CONTRACT CHANGE ORDER NO. 31452
SHEET 2 OF 7

MARK	DATE	DESCRIPTIONS	BY	CH'D	CCO#
1	08/01/13	REMOVE AND TEST SAMPLE RODS	CC	MN	31452
0	06/11/13	REMOVE, REPLACE, AND TEST SAMPLE RODS	CC	MN	31451

SAN FRANCISCO OAKLAND BAY BRIDGE
EAST SPAN SEISMIC SAFETY PROJECT
SELF-ANCHORED SUSPENSION BRIDGE
(SUPERSTRUCTURE & TOWER)

TEST RIG DETAILS NO. 10

ELEVATION - TEST SET UP

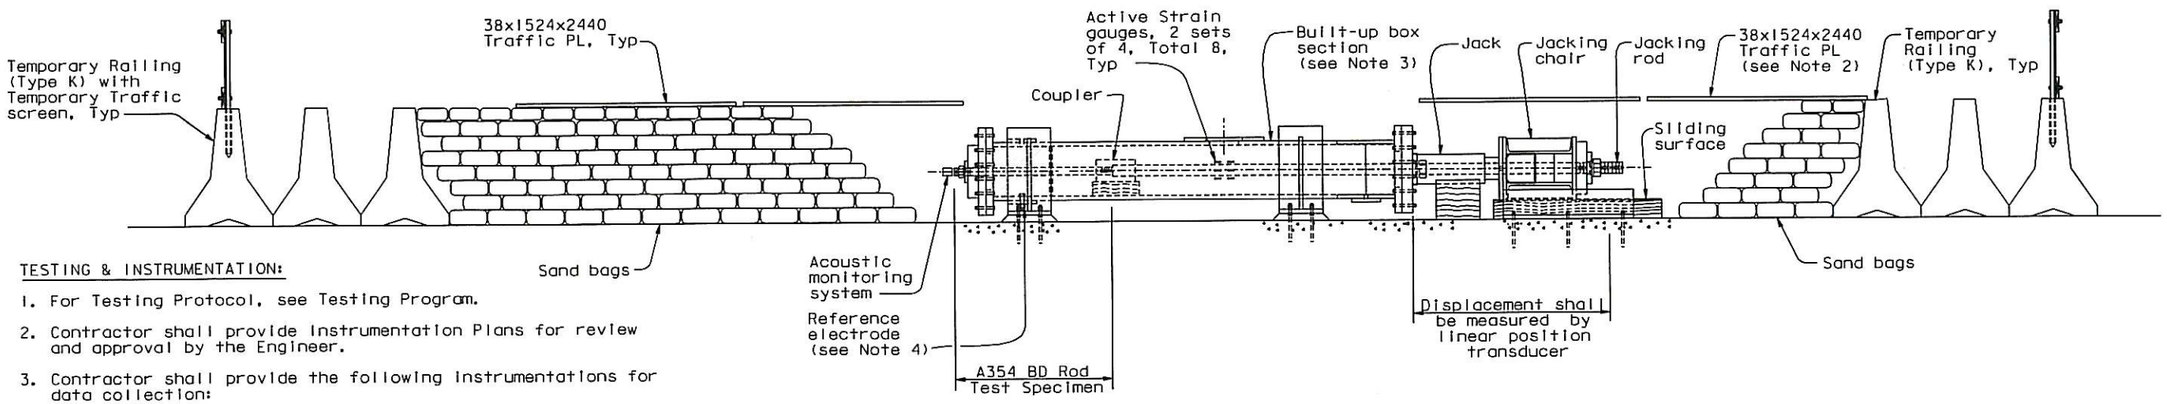
TESTING & INSTRUMENTATION:

1. For Testing Protocol, see Testing Program.
2. Contractor shall provide Instrumentation Plans for review and approval by the Engineer.
3. Contractor shall provide the following instrumentations for data collection:

a. Acoustic monitoring - Micro II Digital AE System with R15I-AST model AE sensor, or equivalent (1 per test specimen)
   b. Linear position transducer (2 per test specimen placed 180° apart)

c. Active strain gauges (8 per test specimen), placed as shown on test specimen.
   d. Secondary strain gauges (8 per test specimen), connect to unstressed steel plate (see Note 5)

e. Reference electrode (1 per test specimen)
   f. Outside air temperature thermocouple (1 per test specimen)
   g. NaCl solution temperature thermocouple (1 per test specimen)

4. The following data shall be collected and recorded against time from the start of the test continuously when applicable. At a minimum, data shall be collected and recorded at the beginning and at the end of each load step, and at an interval not exceeding 8 hours:

a. Load (hydraulic pressure from Jacks, calibrate jacks and pressure gauge)
   b. Displacement
   c. Confirmation of water level above the top of test specimen with plexiglass tube

d. pH level of NaCl solution
   e. Reference electrode readings
   f. Strain gauge readings
   g. Acoustic emission events
   h. Temperatures
5. For each active strain gauge, a secondary strain gauge shall be furnished to provide for thermal compensation. The secondary strain gauge shall be of the same size and lot as the gauge and may be attached to unstressed steel plate inside the box section. The secondary strain gauge shall be connected to the Wheatstone bridge circuit on the same side as the active gauge.

6. Ensure that the threads behind the nut are wet prior to the start of the test.
7. Sets of strain gauges shall be placed 150 mm apart. Strain gauges shall be placed on unthreaded portion of test specimen/jacking rod.

1. Traffic PL's are supported on Temporary Railing (Type K). Alternatively, Traffic PL's may be supported on concrete blocks to achieve desired height. They shall be tied down with wire ropes and anchors, or tied to adjacent Temporary Railing (Type K).
2. ⚠ 300x300 window shall be cut in the traffic PL to allow access for locking off the spherical nut. At the Contractor's option, window may be enlarged, subject to review and approval by the Engineer.
3. For details of built-up box section, see "Test Rig Details No.11 through 14" sheets.
4. For details of reference electrode, see" Test Rig Details No.16" sheet.
5. Test set up shall be shielded from direct sunlight.

LAYOUT PLAN-TEST RIG #5

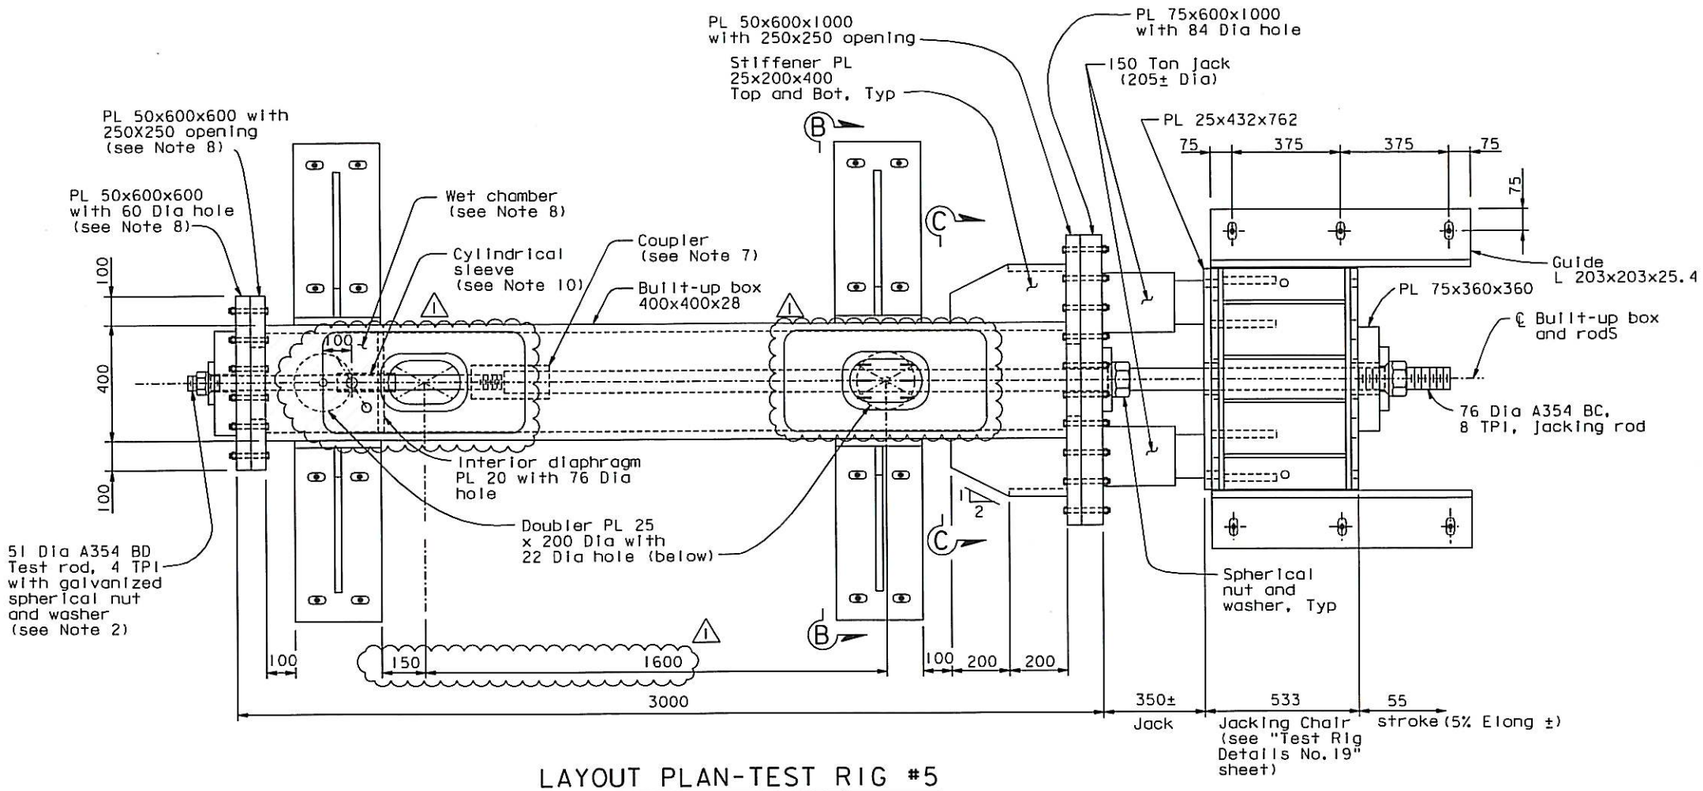
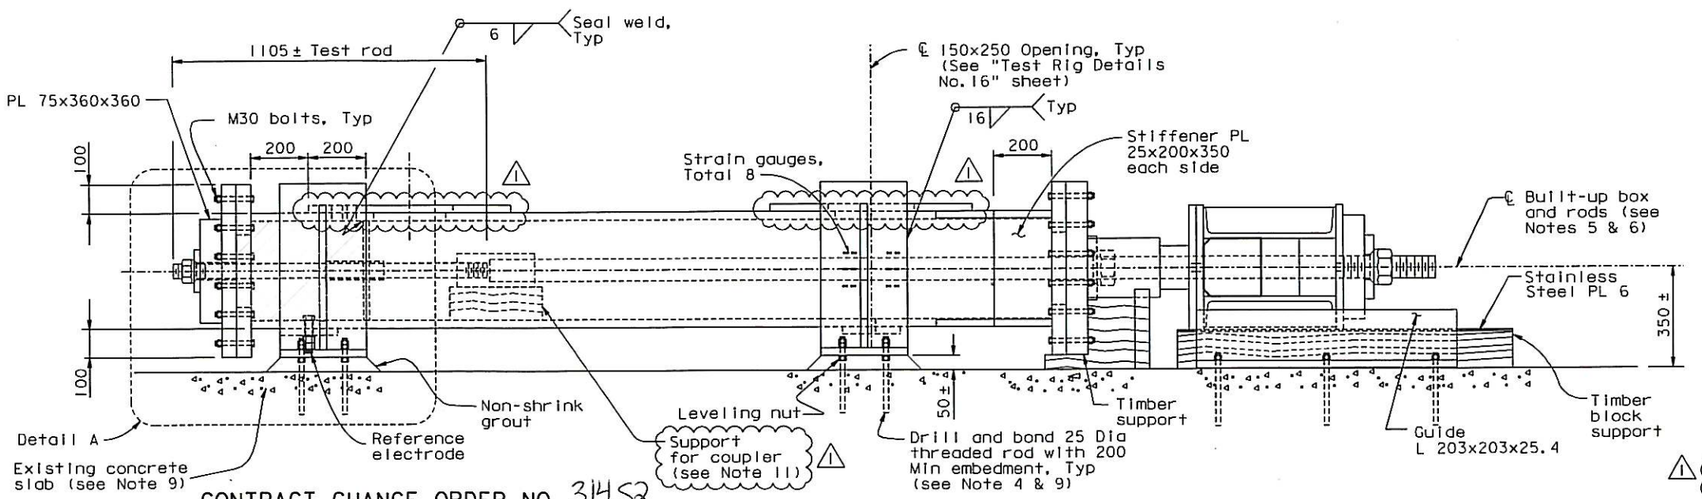
1. For Detail A, Section B-B, and Section C-C, see "Test Rig Details No. 15" sheet.
2. Minimum of 75 mm of threads of the rod shall be submerged in the NaCl solution at the start of the test.

3. Built-up box 400x400x28 shall be used.
4. The drill and bond 25 Dia threaded rods shall have minimum allowable strength of 45 kN in tension and 30 kN in shear per threaded rod. Provide double nuts, snug-tight against steel plates.

5. Test assembly shall be placed level.
6. CL of built-up box and rods shall be aligned to within 4 mm.
7. For coupler detail, see "Test Rig Details No. 16" sheet.

8. All interior wetted surfaces of wet chambers, including inside of holes, shall be painted with two coats of epoxy based system or equivalent. Surface preparation and application procedure shall be per manufacturers' recommendations.

9. Existing concrete shall be 300 thick and shall have minimum strength of 14 MPa, confirm by testing of corings. In the event that foundation thickness or strength cannot be confirmed, reinforced concrete slab foundation shall be provided as shown on "Test Rig Details No. 21" sheet.

10. For cylindrical sleeve detail, see "Test Rig Details No. 16" sheet. Cylindrical sleeve shall be painted with two coats of epoxy based system or equivalent. Surface preparation and application procedure shall be per manufacturers' recommendations.

11. Contractor to propose material for Engineer's review and approval. Material shall be non-metallic and non-expanding in contact with water.

LAYOUT PLAN-TEST RIG #6

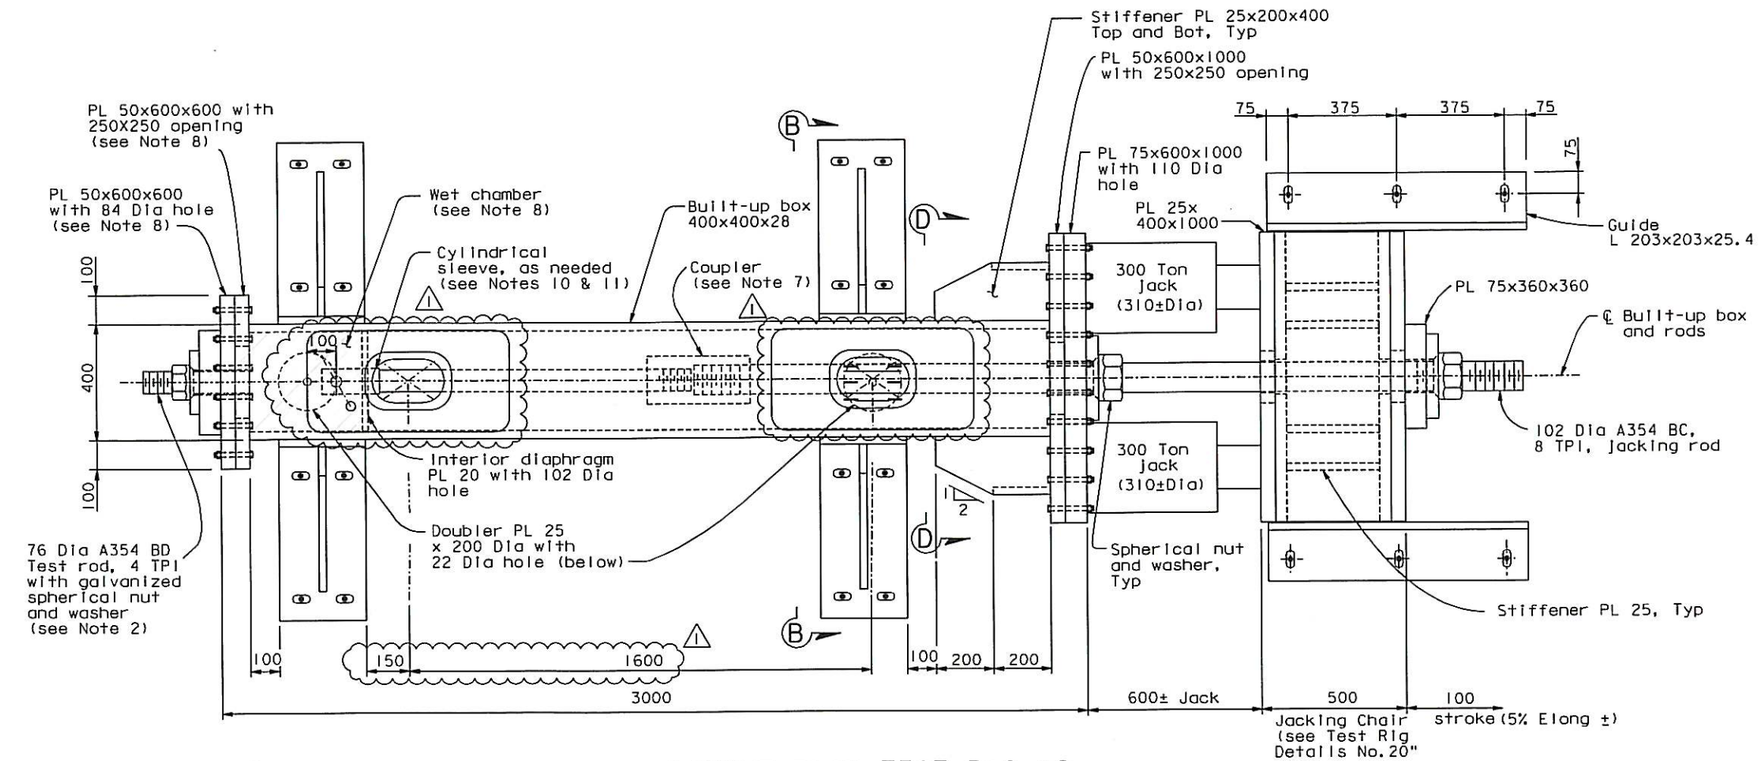
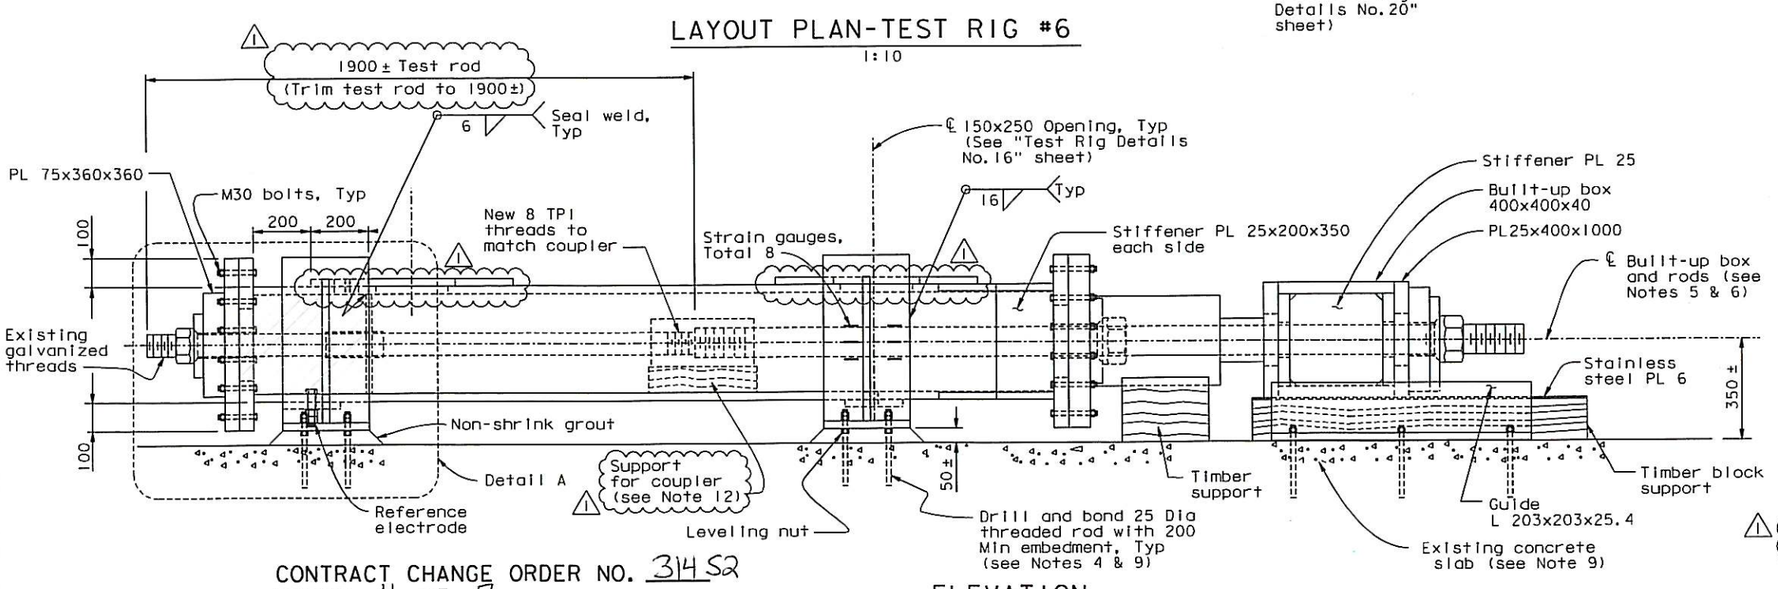
1. For Detail A and Section B-B, see "Test Rig Details No. 15" sheet. For Section D-D, see "Test Rig Details No. 18" sheet.
2. Minimum of 75 mm of threads of the rod shall be submerged in the NaCl solution at the start of the test.

3. Built-up box 400x400x28 shall be used.
4. The drill and bond 25 Dia threaded rods shall have minimum allowable strength of 45 kN in tension and 30 kN in shear per threaded rod. Provide double nuts, snug-tight against steel plates.

5. Test assembly shall be placed level.
6. CL of built-up box and rods shall be aligned to within 4 mm.
7. For coupler detail, see "Test Rig Details No. 16" sheet.

8. All interior wetted surfaces of wet chambers, including inside of holes, shall be painted with two coats of epoxy based system or equivalent. Surface preparation and application procedure shall be per manufacturers' recommendations.

9. Existing concrete shall be 300 thick and shall have minimum strength of 14 MPa, confirm by testing of corings. In the event that foundation thickness or strength cannot be confirmed, reinforced concrete slab foundation shall be provided as shown on "Test Rig Details No. 21" sheet.

10. Install cylindrical sleeve if threads extend to interior diaphragm.
11. For cylindrical sleeve details, see "Test Rig Details No. 16" sheet. Cylindrical sleeve shall be painted with two coats of epoxy based system or equivalent. Surface preparation and application procedure shall be per manufacturers' recommendations.

12. Contractor to propose material for Engineer's review and approval. Material shall be non-metallic and non-expanding in contact with water.

LAYOUT PLAN-TEST RIG #7
1:10

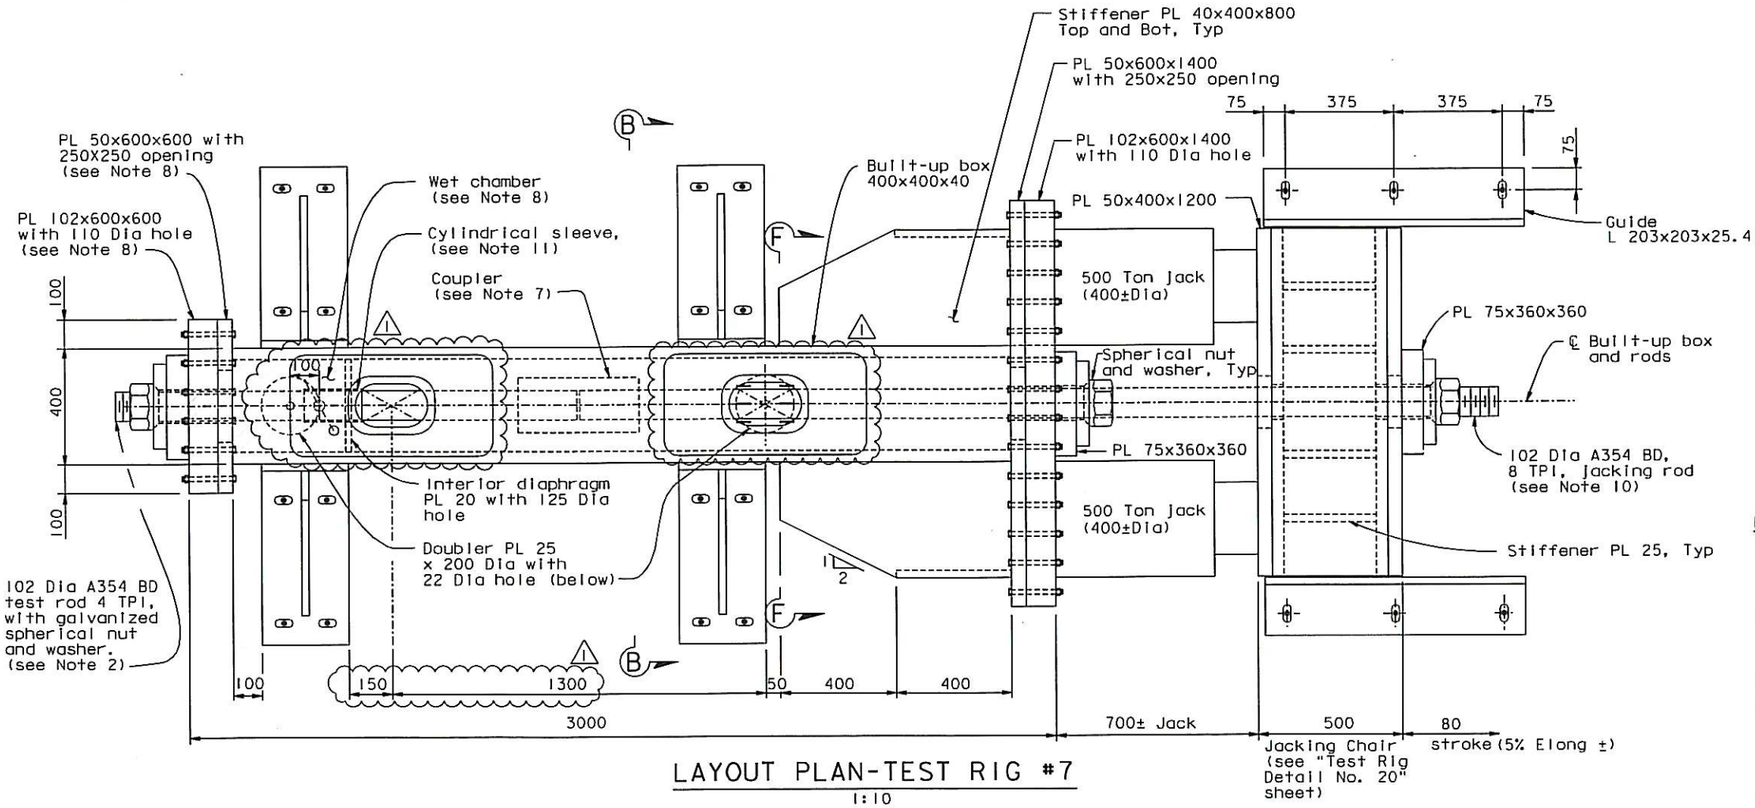
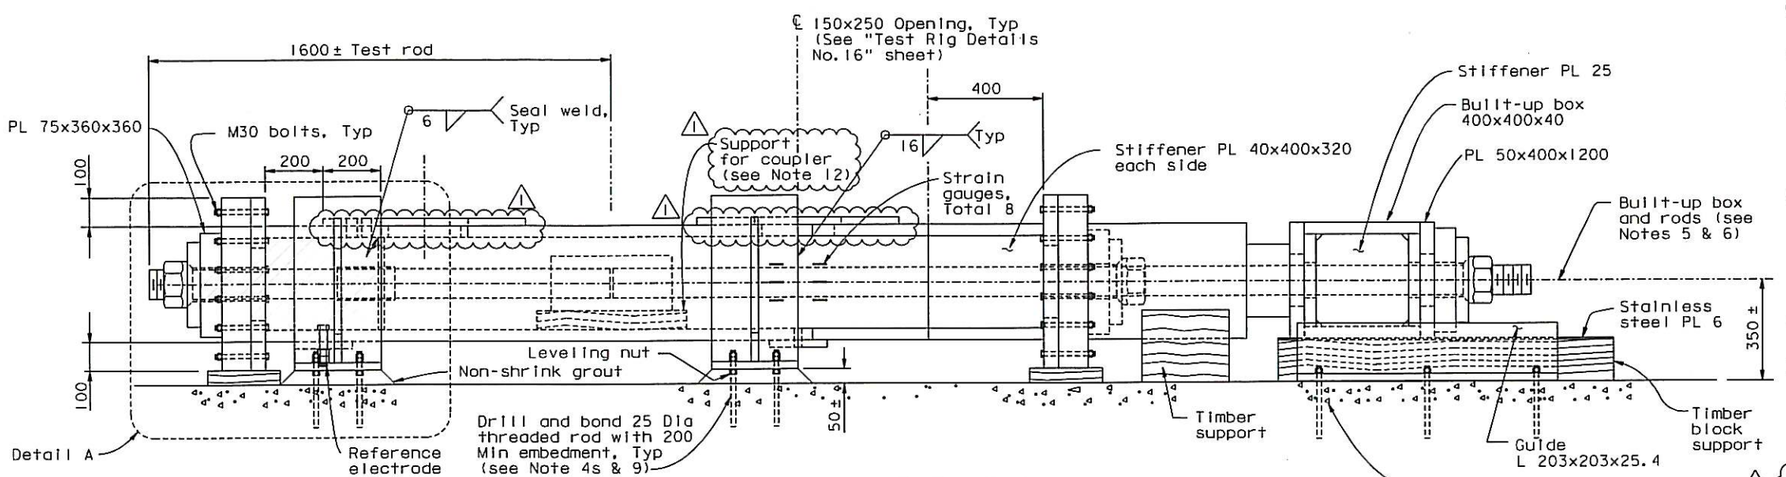
1. For Detail A and Section B-B, see "Test Rig Details No. 15" sheet. For Section F-F, see "Test Rig Details No. 18" sheet.
2. Minimum of 75 mm of threads of the rod shall be submerged in the NaCl solution at the start of the test.

3. Built-up box 400x400x40 shall be used.
4. The drill and bond 25 Dia threaded rods shall have minimum allowable strength of 45 kN in tension and 30 kN in shear per threaded rod. Provide double nuts, snug-tight against steel plates.

5. Test assembly shall be placed level.
6. CL of built-up box and rods shall be aligned to within 4 mm.
7. For coupler detail, see "Test Rig Details No. 16" sheet.

8. All interior wetted surfaces of wet chambers, including inside of holes, shall be painted with two coats of epoxy based system or equivalent. Surface preparation and application procedure shall be per manufacturers' recommendations.

9. Existing concrete shall be 300 thick and shall have minimum strength of 14 MPa, confirm by testing of corings. In the event that foundation thickness or strength cannot be confirmed, reinforced concrete slab foundation shall be provided as shown on "Test Rig Details No. 21" sheet.

10. Provide mill certificate showing Fy of Jacking rod to be greater than Fy of test specimen by 10%.
11. For cylindrical sleeve details, see "Test Rig Details No. 16" sheet. Cylindrical sleeve shall be painted with two coats of epoxy based system or equivalent. Surface preparation and application procedure shall be per manufacturers' recommendations.

12. Contractor to propose material for Engineer's review and approval. Material shall be non-metallic and non-expanding in contact with water.
